Project: 3925 - Franklin Co. Courthouse
 100 Public Square
 Benton, Illinois 62812
 Phone: 618-687-3900
 Fax: 618-687-3639

Prime Contract Potential Change Order #061: R.F.P. #17 - Door Changes

RE: Franklin County Courthouse – PR017 (Access Control Addition)

Proposal Request Number: 017

1 DELAYED EGRESS DOOR SIGNAGE

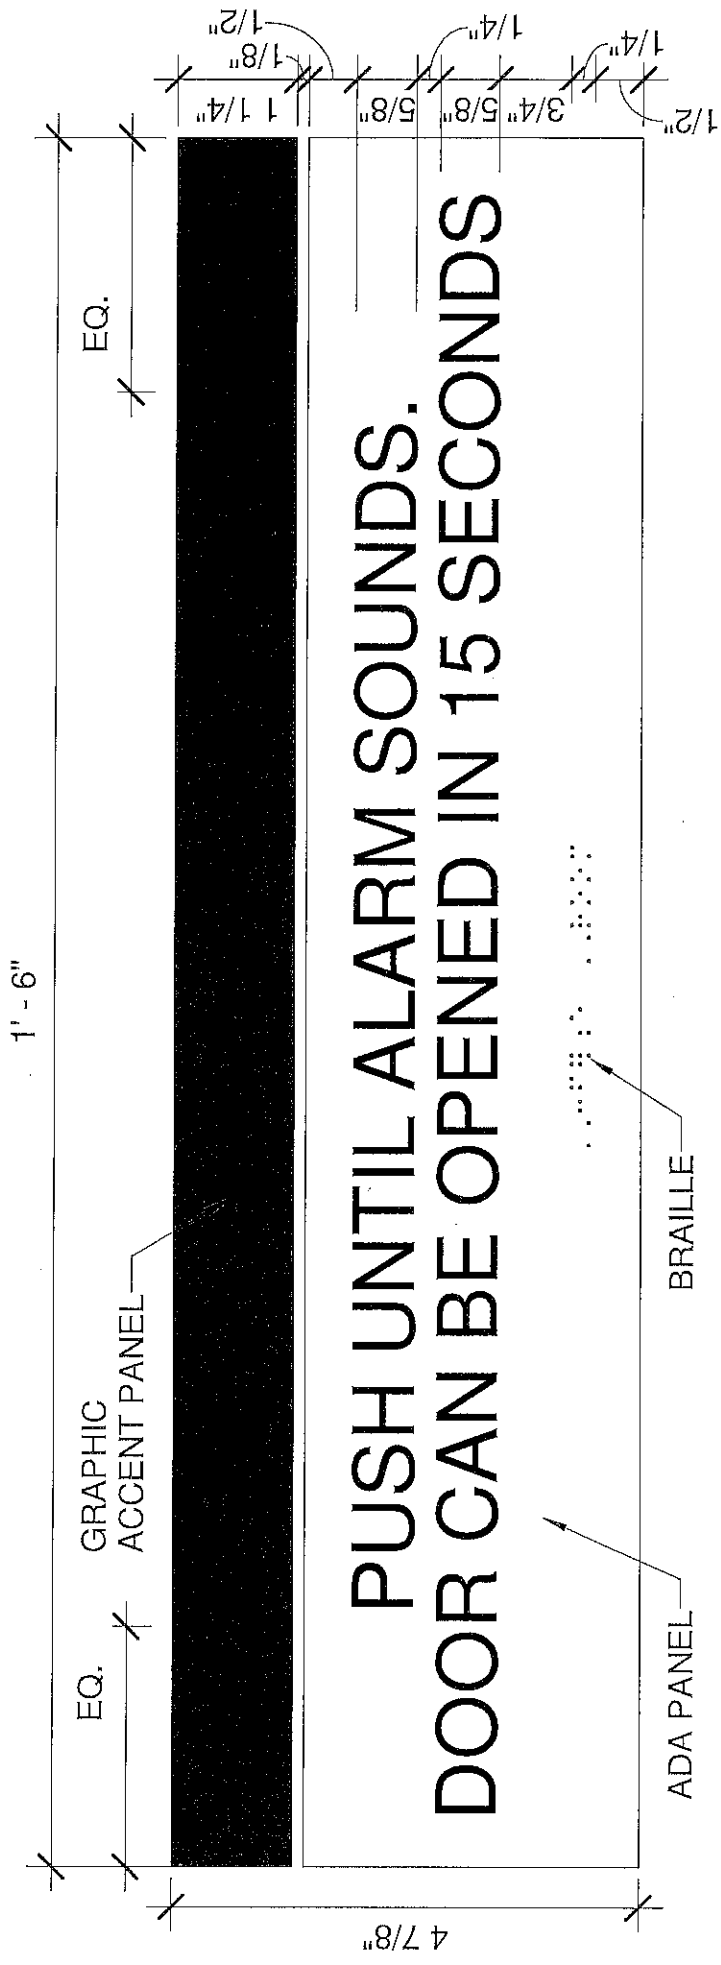
Provide sign at Doors 208C, 218C, and 308C. Install sign 12 inches (max) above door exit hardware, center on door. Sign to conform to requirements shown on attached Detail 1 / RFP17.1.

PUSH UNTIL ALARM SOUNDS.
DOOR CAN BE OPENED IN 15 SECONDS
